**From:** [Vincent](#)  
**To:** [Abi Mark](#)  
**Cc:** [Tony Clow](#); [Richard](#); [Natalie Rutland](#); [Vanessa Hamm](#)  
**Subject:** RE: PC95 - Questions and 42A topics  
**Date:** Monday, 13 May 2024 12:37:40 pm  
**Attachments:** [image002.jpg](#)  
[image003.gif](#)  
[s.42A Points, Urban, Urban Env Letter May 24.pdf](#)  
[Structure Plan - Pongakawa - 09.05.2024.pdf](#)  
[Appendix B Chapter 12 Amends Post-Notification.docx](#)

## **Plan Change 95 – Questions and s.42A Topics NPS-UD 2020 Considerations**

## Pencarrow Estate Pongakawa - General Layout & Infrastructure

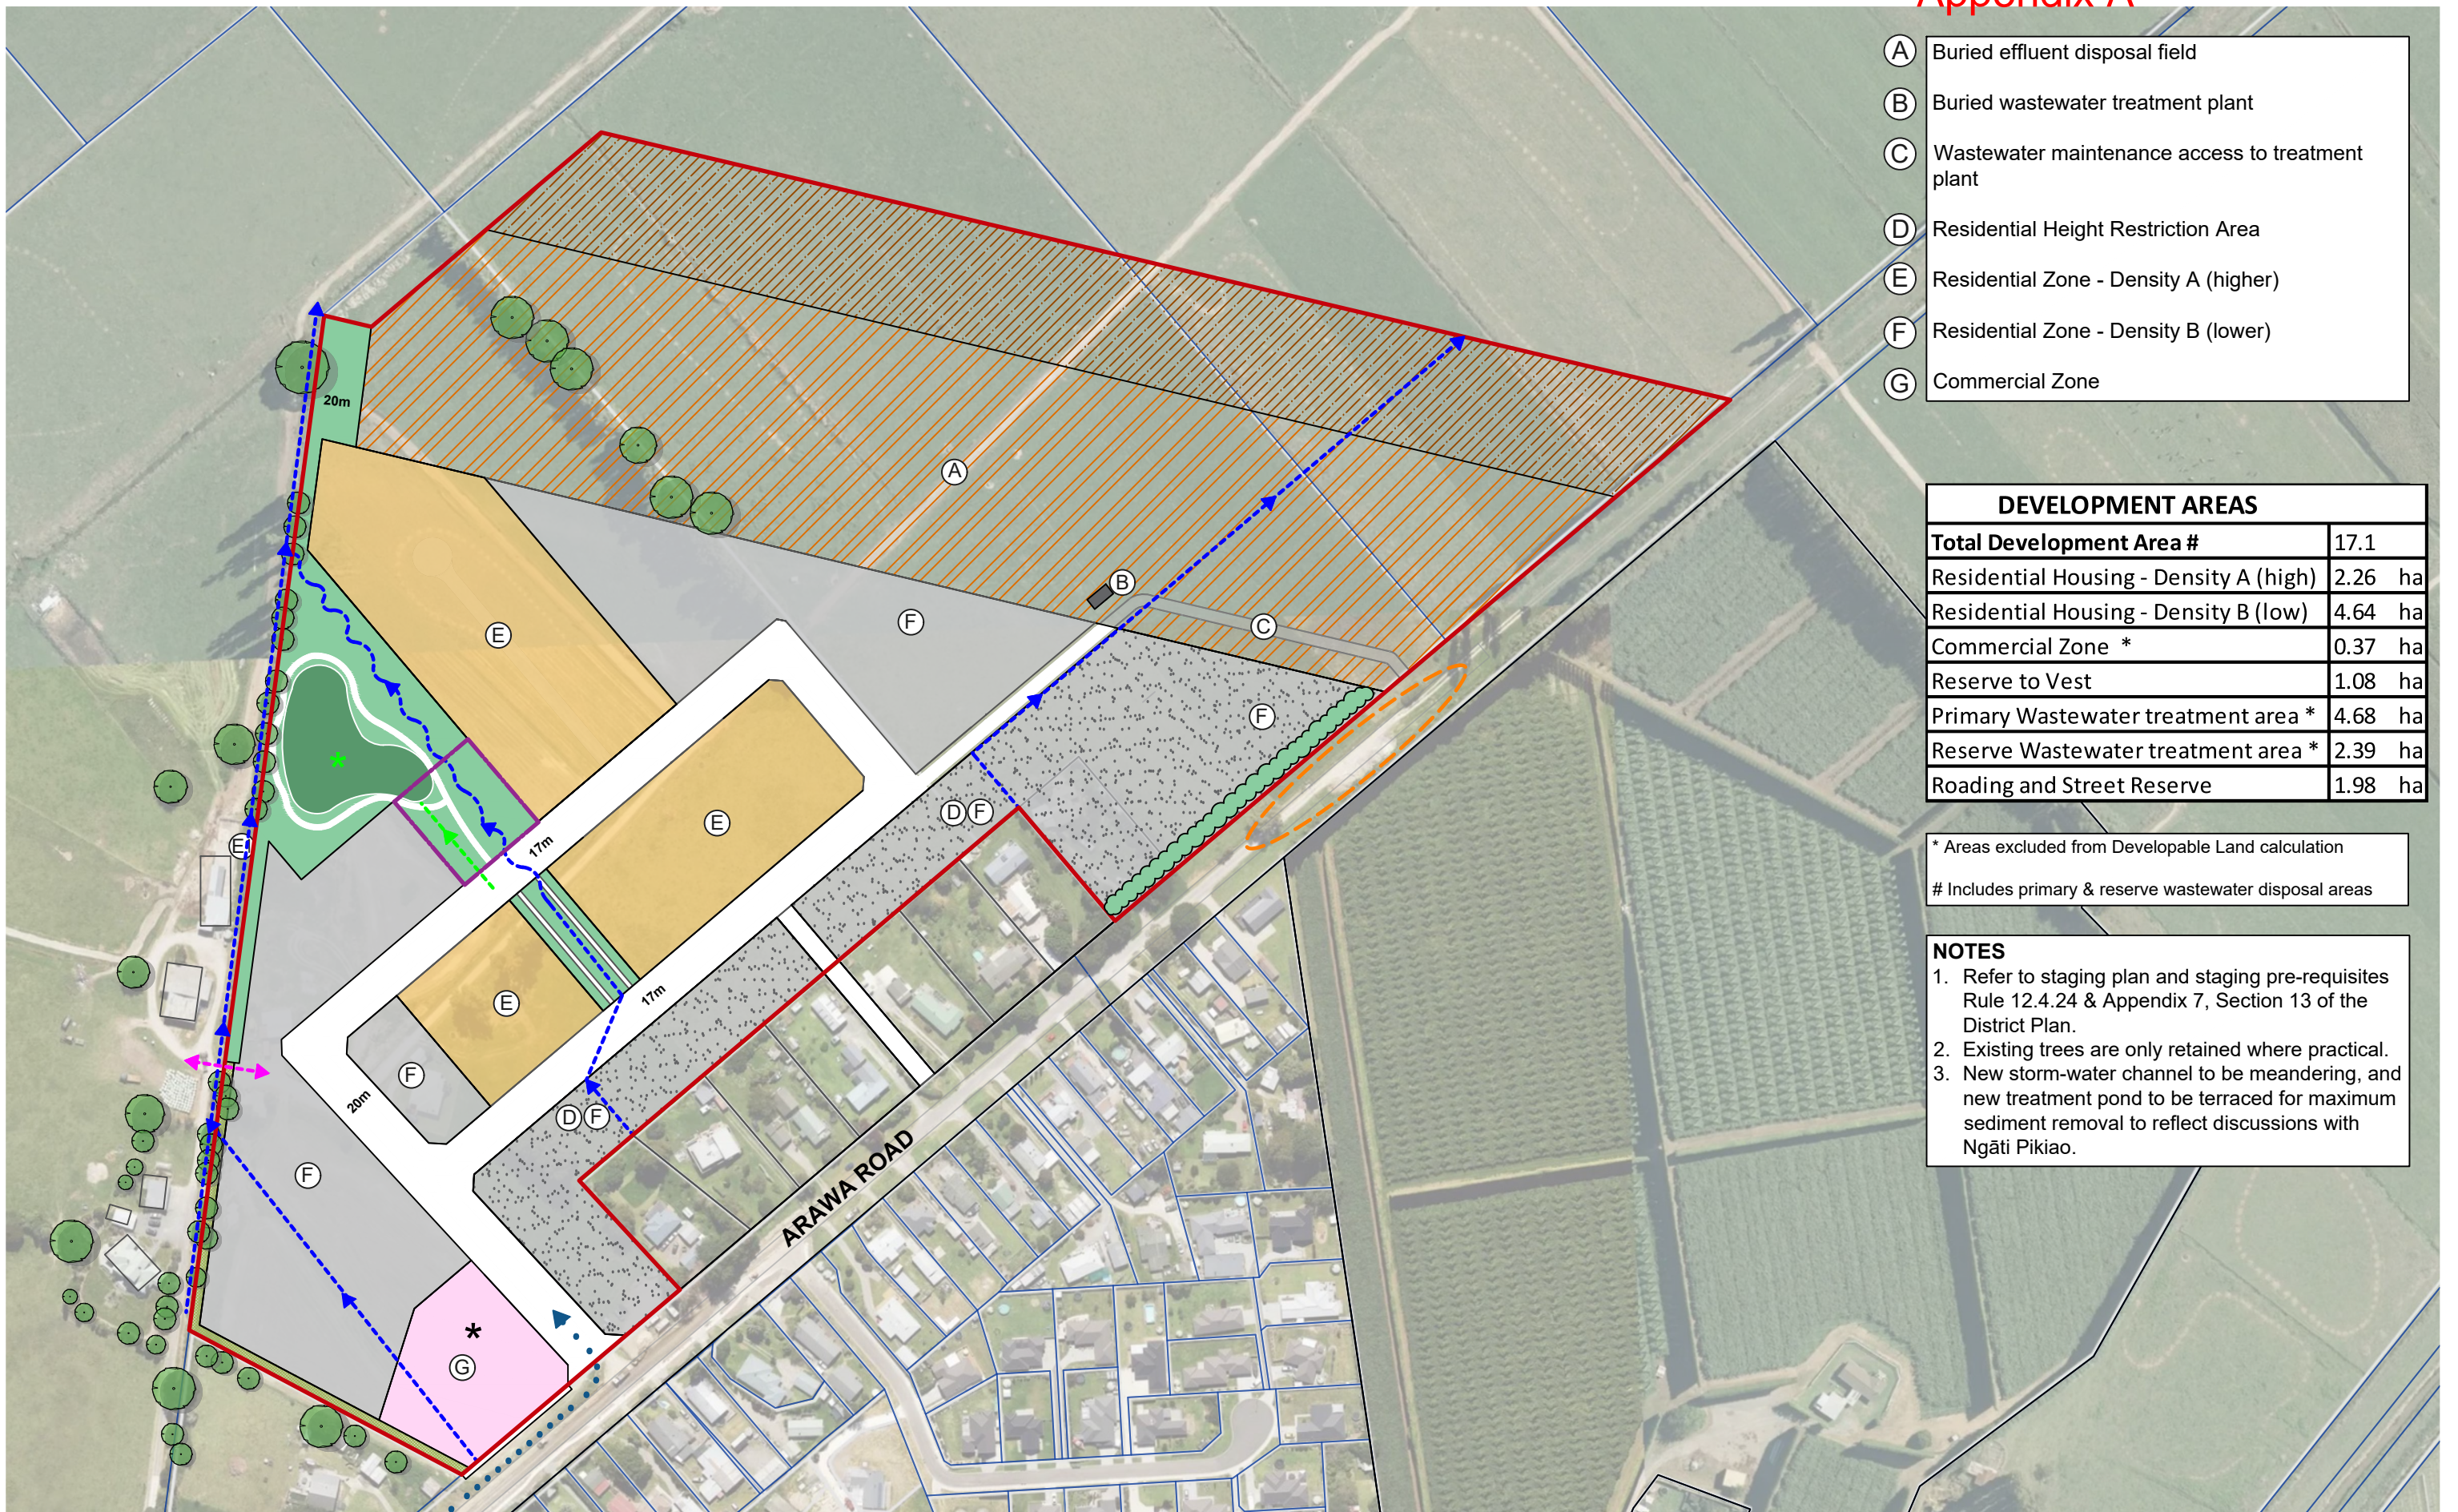
- Structure plan minor errors.
  - As discussed in the meeting on Tuesday there are a couple of errors in the structure plan that I have noted so far where the lettering in the key doesn't align with the proposed plan/rules.

- Proposed section 12 rules say commercial zone established in stage 1. This is not well reflected on the staging map.
- Riparian set back
  - Can you please confirm which distance you are proposing to use. I understand the area south of the bridge will be 4m however there have been a number of discrepancies in your other communications. In the submission response letter, you have said that the riparian set back is 8m, in the response to BOPRC you have stated 6m and in the structure plan (as discussed) the area north of the bridge has been labelled as having 4m. Please clarify.

6. **Reverse sensitivity.** We have consulted with horticultural operators in the WBOPDC (Southern Orchards) who have advised that subject to the inclusion of a shelterbelt along the Arawa Road frontage at the northern end of the plan change site, no further notification of properties would be required when following standard spray consultation practice. As such, a shelterbelt requirement has been added to the proposed Structure Plan and pre-requisites for Stage 3 where it is located.

2. **Structure plan minor errors.** Please see attached revised drawing set which we believe corrects the labelling inconsistencies we have previously discussed. This includes an amended staging plan showing the commercial area to be delivered at Stage 1 consistent with the proposed rules / staging pre-requisites within Chapter 12.

3. **Riparian setback.** To address any previous ambiguity: south of the existing farm bridge over the Puanene Stream, a Landscape Buffer strip over private land is proposed, spaced at 4m wide to accommodate future planting in accordance with the structure plan. North of the existing farm bridge, a 6m wide reserve strip, contiguous with the stormwater and ‘village green’ reserve, is proposed alongside the Puanene Stream. Any reference to 8m is out of date.
